UHCC - PC42 Hearing

Flood Maps Must Be Accurate

Save Our Hills (Upper Hutt) Inc.

GWRC Topography Wrong for 27 Elmslie Road, Pinehaven – Cross- Section at Chainage 640

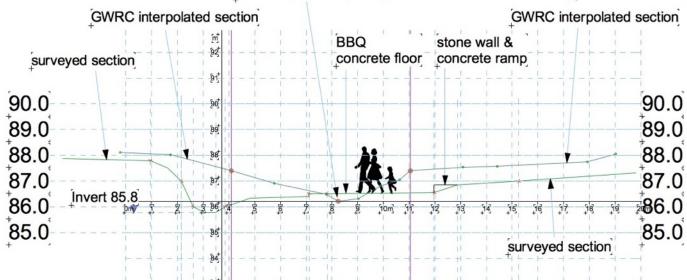
assumed location of GWRC's invert (based on GWRC Flood Map showing deepest flood level over BBQ floor)
